Technical Service Bulletin: TSB140152

New Turbocharger Oil Supply Line for QSK19 CM850 and CM2150

This document introduces a new turbocharger oil supply line for QSK19 CM850 and CM2150 engines using engine option TP 4725.

Figure 1, New Turbocharger Oil Supply Line

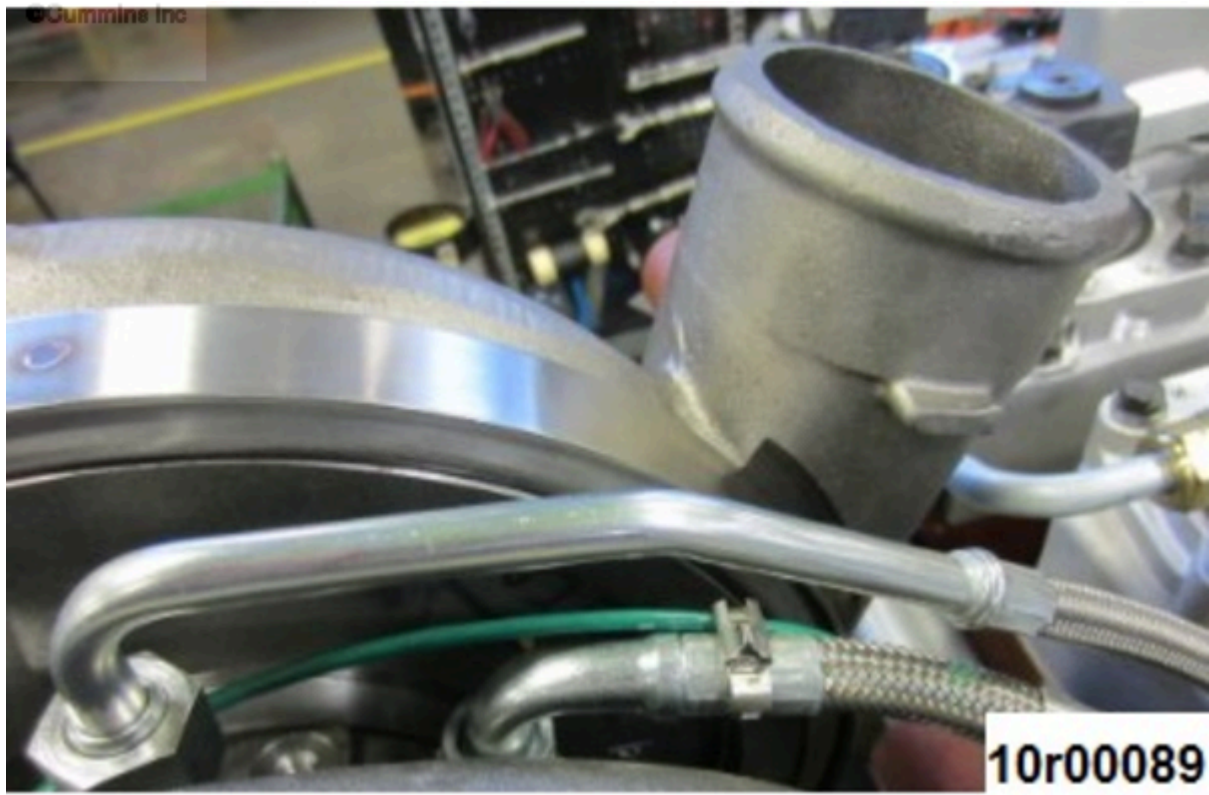
A section of rigid tube has been added to the new turbocharger oil supply line. This change improves orientation of the turbocharger oil supply line between the turbocharger turbine housing and turbocharger coolant supply line.
